LV Rooms added (North Elevation)

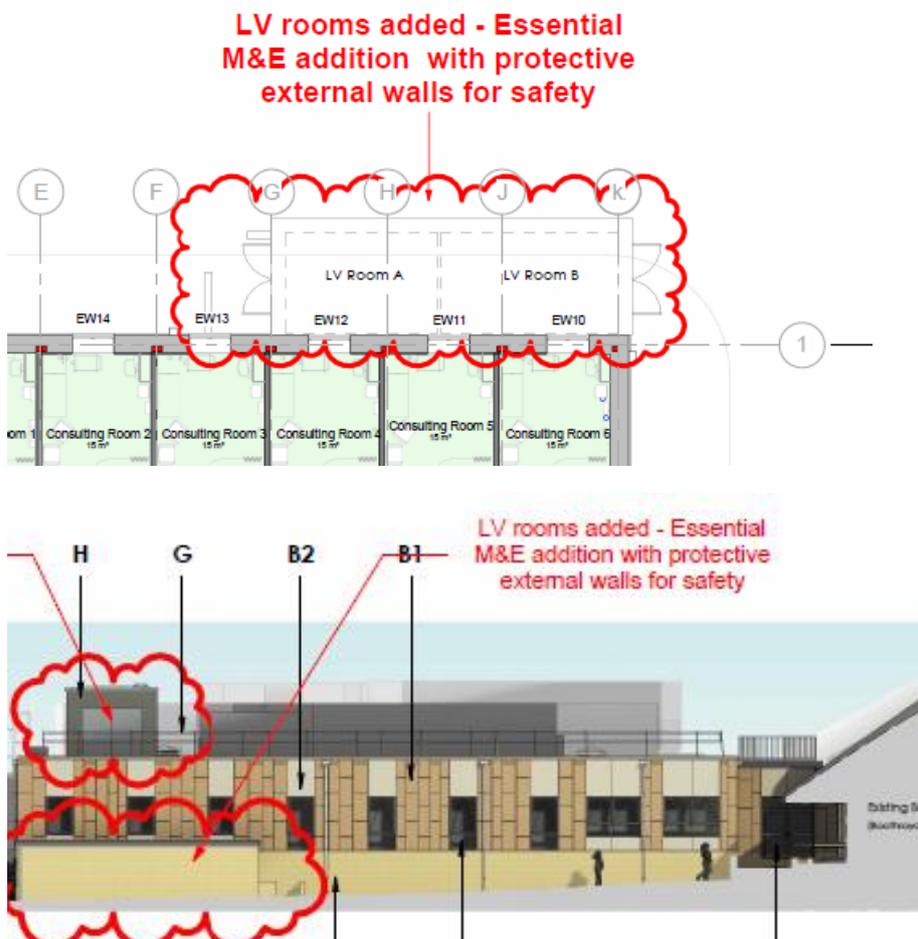
It was identified through detailed design development that the existing hospital electrical infrastructure could not adequately support the new building's power demands. As a result, additional electrical infrastructure was required, including the installation of two Low Voltage (LV) panels.

These panels needed to be positioned in close proximity to the building to maintain efficient cable runs and operational safety. For fire safety and maintenance accessibility, the LV panels were housed within an external outbuilding accessible only from outside the main building envelope, thereby reducing internal fire load and ensuring compliance with IET Wiring Regulations (BS 7671).

The north elevation was selected as the most appropriate location based on spatial availability, access for maintenance personnel, and separation from public areas. To mitigate safety risks during maintenance, a self-supporting wall was constructed adjacent to the LV room entrance to prevent door swings from impeding pedestrian routes. This wall also functions as a sacrificial barrier to absorb impacts in the unlikely event of vehicular collision, thus safeguarding the electrical equipment.

A protective crash rail was also installed along the north elevation to further enhance resilience and protect critical infrastructure.

CAT Ladder relocated (East Elevation)

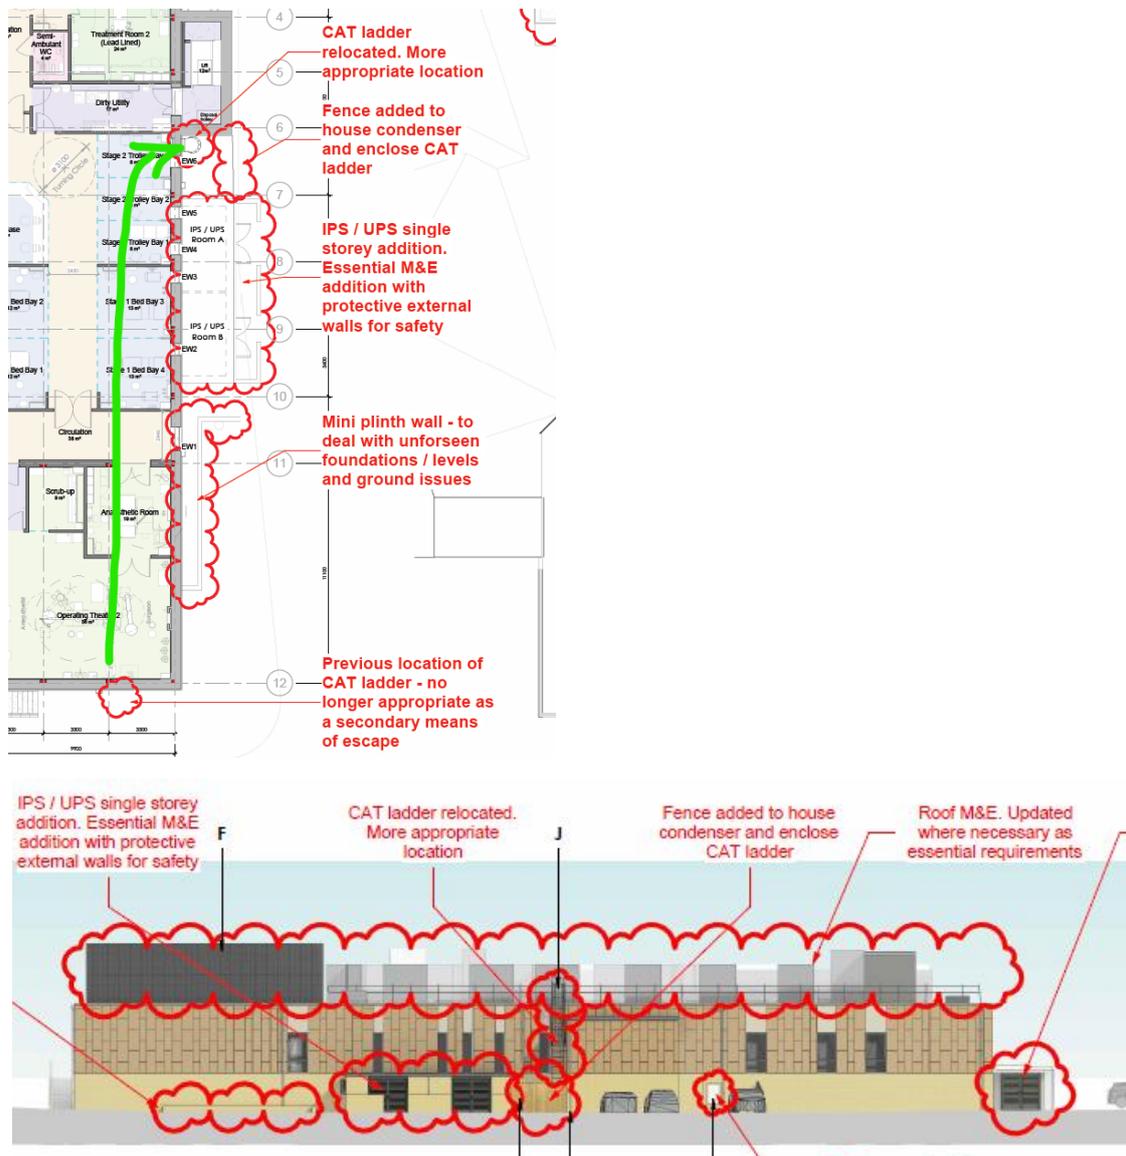
The original location of the CAT ladder on the south elevation was reviewed and deemed unsuitable following design changes to the roof layout.

As part of a reassessment of fire strategy and safe access provisions, escape distances for a secondary means of escape were recalculated in accordance with Approved Document B of the Building Regulations.

A new location was identified that met the required safety criteria while also allowing the ladder to be enclosed within a secure area, thereby preventing unauthorised access and enhancing site safety.

The revised placement offers improved functionality and reduces visual and physical obstruction, particularly as the original location was along a pedestrian route where it may have posed both a hazard and a point of concern in terms of appearance and usability.

New enclosed staircase added (to replace a CAT ladder). (West Elevation)

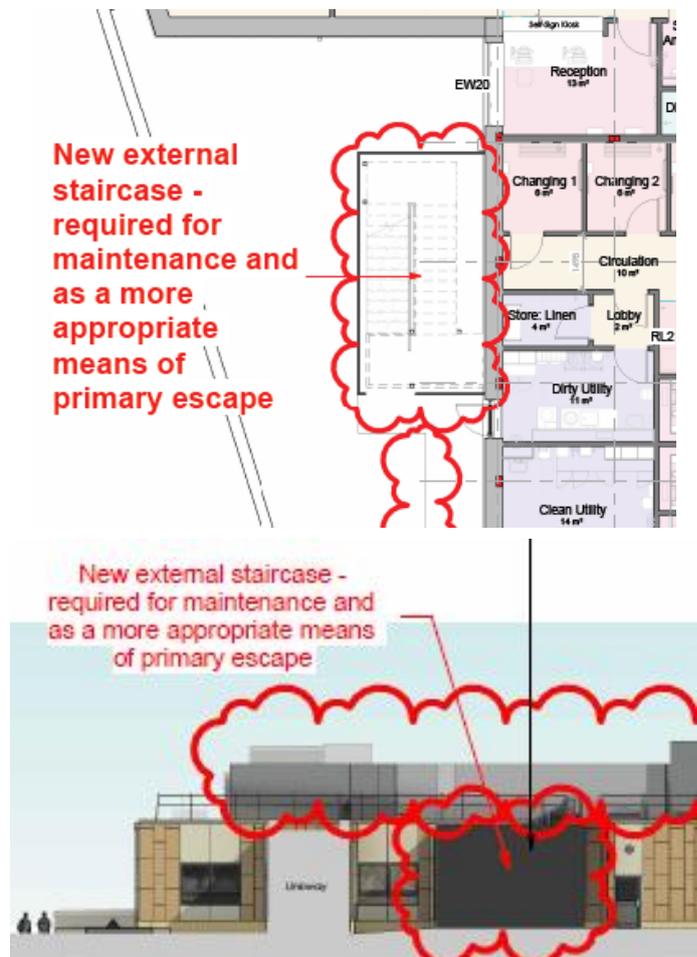
The existing CAT ladder on the west elevation was replaced with an external staircase, following a design review which concluded that a staircase would offer a significantly safer and more practical primary means of access to the roof.

Unlike a CAT ladder, the staircase facilitates the movement of maintenance personnel and the transport of equipment in compliance with CDM Regulations 2015, which require safe access for maintenance activities. The revised access solution enhances both functionality and user safety.

The staircase structure was clad on three sides with metal panels finished in RAL7016 to ensure visual coherence with the building façade while maintaining weather protection.

The cladding was terminated at parapet height to reduce visual impact, as a fully enclosed roofed structure was considered disproportionate in scale and contextually inappropriate. This design approach ensured a modest and functional appearance that remains sympathetic to the surrounding architecture.

Access to the staircase is controlled via a lockable gate to restrict entry to authorised maintenance personnel only.

Fence added (East Elevation)

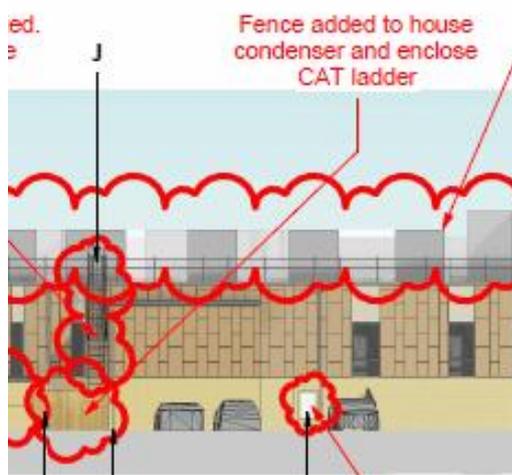
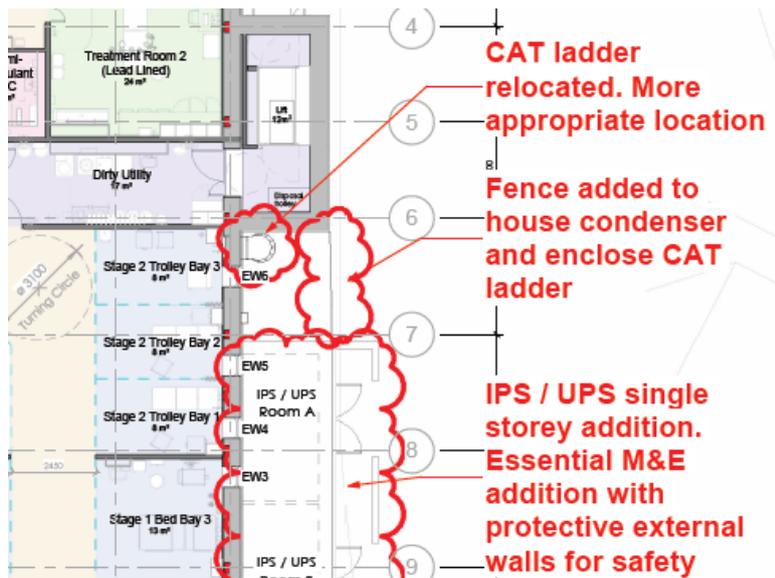
The proposed relocation of the CAT ladder to the area between the IPS/UPS rooms and the lift was reassessed due to significant health and safety and security concerns.

Its placement in this location could have enabled unauthorised access to the roof, presenting a risk to both personnel and infrastructure. In line with fire safety strategy and best practice, it was determined that the CAT ladder should serve exclusively as a secondary means of escape from the roof in emergency scenarios, rather than as a primary access route.

The newly installed external staircase provides the designated primary access, ensuring safe and controlled maintenance entry. To fully secure the CAT ladder, a vertical close-boarded timber fence was installed between the IPS/UPS rooms and the lift. This enclosure, fitted with a lockable gate, restricts access to authorised personnel only.

Additionally, the space within this secure area accommodates condenser pumps, offering a suitable and protected environment for essential air conditioning equipment, while maintaining compliance with mechanical services requirements.

IPS / UPS rooms added (East Elevation)

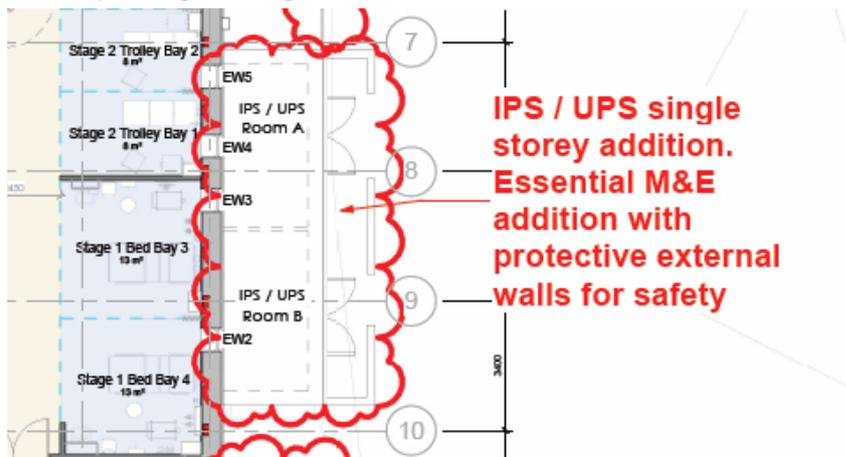
Similar to the LV panel installation, the IPS (Instant Power Supply) and UPS (Uninterruptible Power Supply) rooms form a critical component of the building's electrical infrastructure.

Due to the technical specification of the equipment and the need to optimise internal space planning, it was determined that these rooms would be best accommodated within an external outbuilding, accessible from outside. This arrangement allows for improved environmental control and ventilation, ensuring the reliable operation of sensitive power equipment.

Locating the rooms externally also minimises the fire load and operational risk to the main building and its occupants.

To further enhance safety, a self-supporting wall was constructed adjacent to the IPS/UPS outbuilding. This wall prevents obstruction of pedestrian routes by allowing maintenance doors to open freely and safely, and it serves as a sacrificial barrier, designed to absorb impacts in the unlikely event of a collision or external incident, thereby safeguarding the critical infrastructure within.

IPS / UPS single storey addition. Essential M&E addition with protective external walls for safety

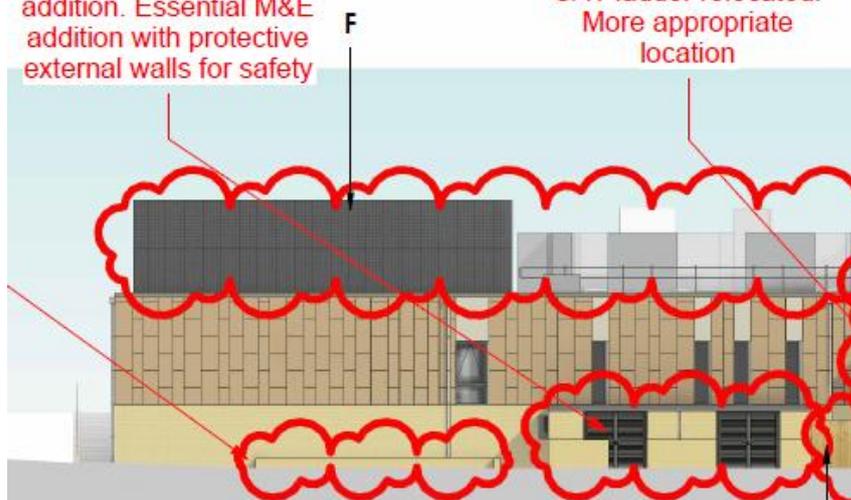
CAT ladder relocated. More appropriate location

Mini plinth wall added (East Elevation)

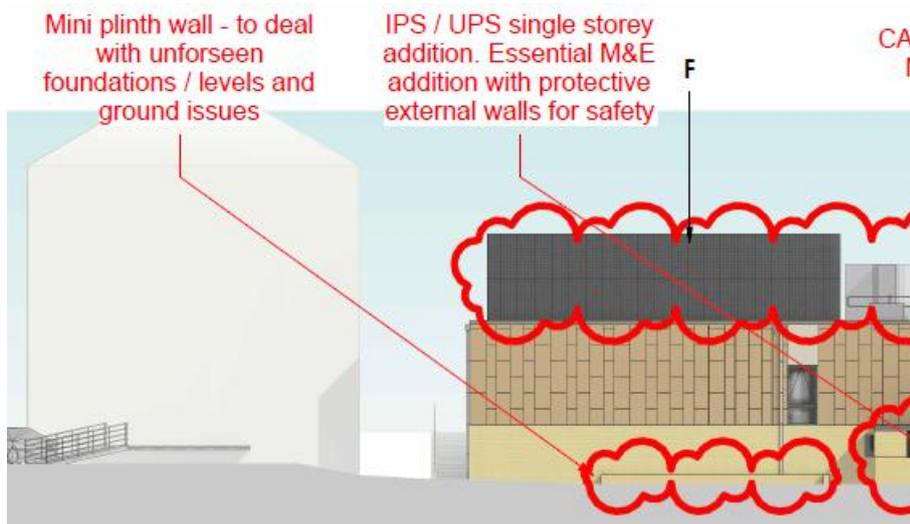
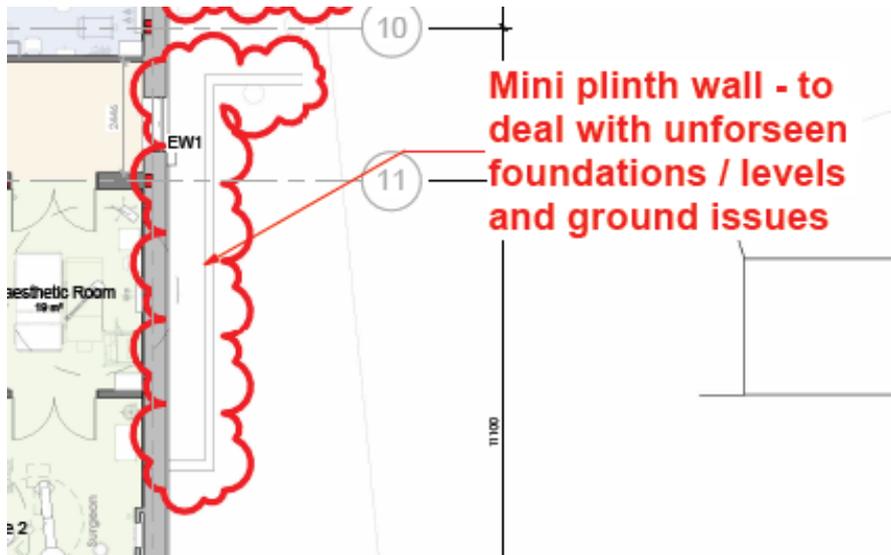
The south-east corner of the building sits at the lowest point in the surrounding topography and is densely occupied by essential services and infrastructure, resulting in several spatial and level-related constraints.

During the implementation of the landscaping plan, sections of the structural foundations were found to be exposed. As these foundations are critical to the integrity of the building, any modification, such as cutting into them, was deemed unacceptable.

To address this, a practical and visually coherent solution was developed: a low plinth wall was introduced to conceal the exposed elements. This design not only preserved the structural integrity of the building but also allowed the landscaping and pedestrian pathway to function as intended. The wall worked effectively with the existing ground levels and enabled the formation of a DDA-compliant (Disability Discrimination Act) accessible route. This approach successfully resolved the competing requirements of structural protection, aesthetics, and accessibility.

External door omitted (West Elevation)

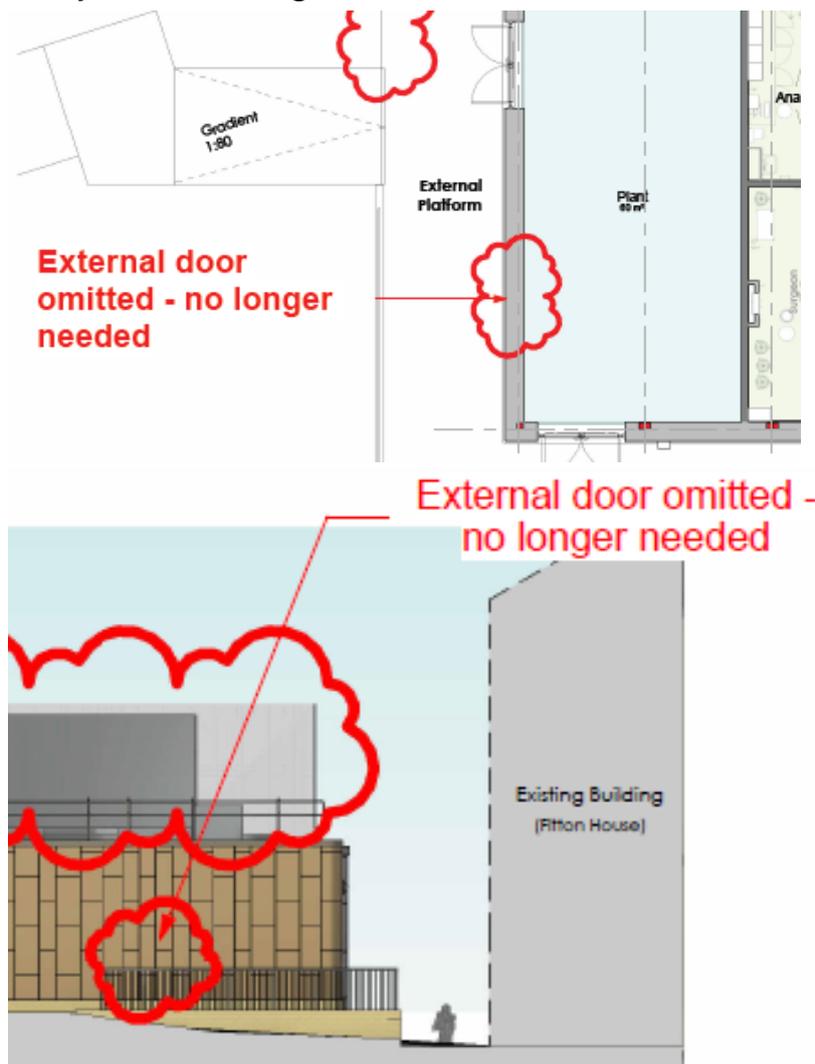
The original design included a large plant room requiring two means of escape, along with a smaller adjacent plant room that only required a single point of access. However, during the refinement of the mechanical and electrical (M&E) layout, it was determined that a single, larger plant room would be more operationally efficient and spatially effective. As a result, the internal partition was removed to consolidate the two spaces.

The new combined plant room configuration featured three external doors, exceeding the necessary means of escape and access requirements. Given the revised M&E layout and the need to align key services along the perimeter wall, the door located at the far south end of the west elevation became redundant. The remaining two doors provided sufficient access and egress in accordance with Approved Document B of the Building Regulations.

The removal of the third door was therefore both functionally and visually appropriate, offering a cleaner elevation and having no adverse impact on the building's operation, safety, or surrounding context.

Walkway wall and railing omitted (West Elevation)

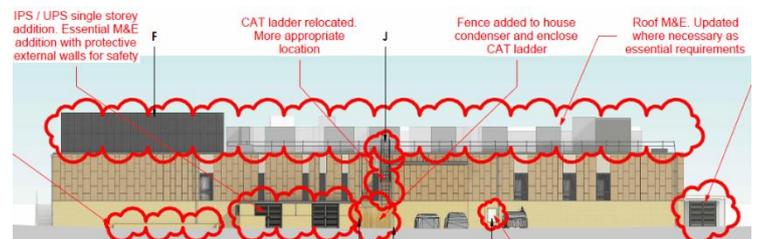
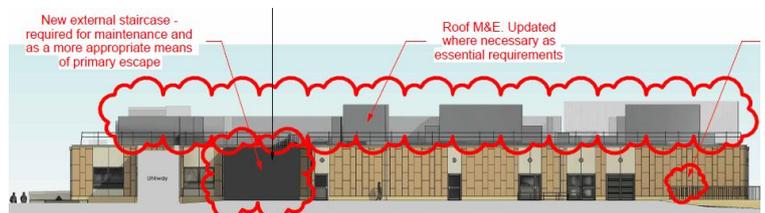
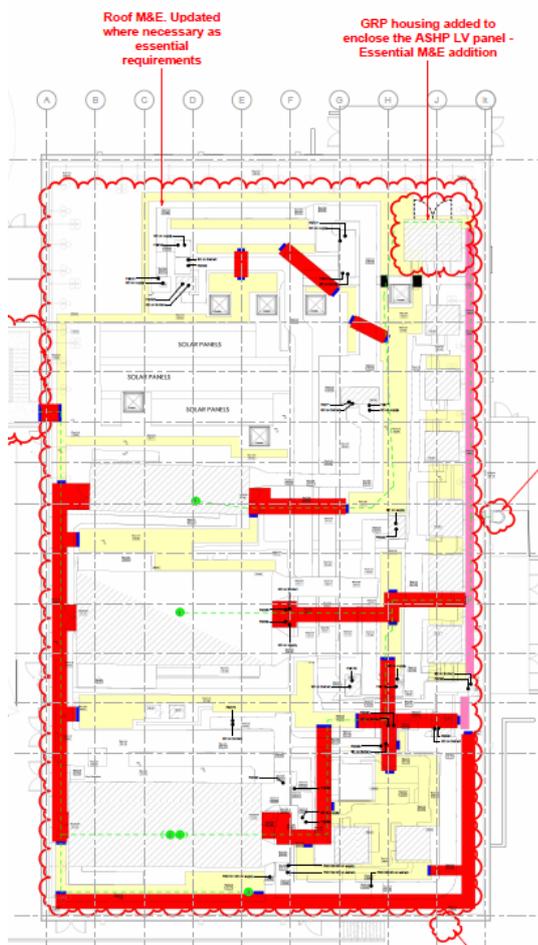
As the project progressed on site, the walkway and retaining wall design underwent refinement to address emerging technical and structural constraints. The initial proposal involved a retained walkway supported by deep foundations in close proximity to the existing Boothroyd building. This raised concerns over potential interference with the existing foundations, prompting a reassessment of the design. In parallel, the incorporation of a gas membrane, introduced as a precautionary measure to mitigate ground gas risks, rendered the original solution of a retaining wall with earth banked beneath the building unfeasible, as it would restrict necessary undercroft ventilation.

A revised detail was developed featuring a single deep foundation along the west elevation perimeter, supporting a reinforced retaining wall to stabilise the adjacent ground. This solution preserved structural integrity and ensured adequate airflow below the building in compliance with guidance in CIRIA C665.

The new approach eliminated the need for a separate perimeter wall and handrail at a level change, allowing for a more traditional pathway design using pin kerbs and regraded landscaping, resulting in a more elegant, buildable, and context-sensitive solution.

GRP housing added (Roof Plan)

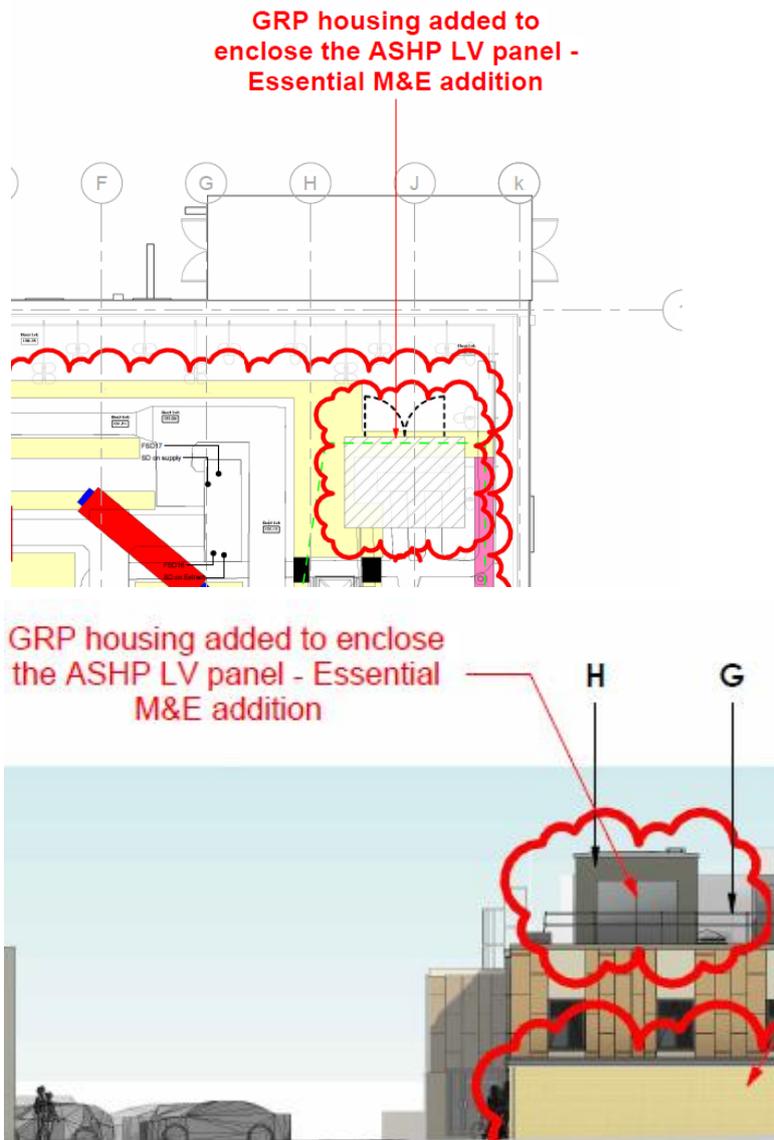
Like the LV and IPS/UPS rooms, the GRP housing serves as a protective enclosure for a critical component of the building's power infrastructure, specifically the Air Source Heat Pump (ASHP) Low Voltage (LV) panel. As the ASHP units are located on the roof, the LV panel must be positioned in close proximity to ensure efficient operation and compliance with electrical safety standards (BS EN 61439).

The GRP enclosure is primarily functional, designed to meet regulatory size requirements while minimising its visual impact. To achieve this, the GRP was specified in a grey finish closely matching the existing plant equipment on the roof, allowing it to blend seamlessly with the rooftop plant area.

This design approach reduces the architectural prominence of the enclosure, ensuring it complements the overall building aesthetic and respects the visual character of the surrounding context.
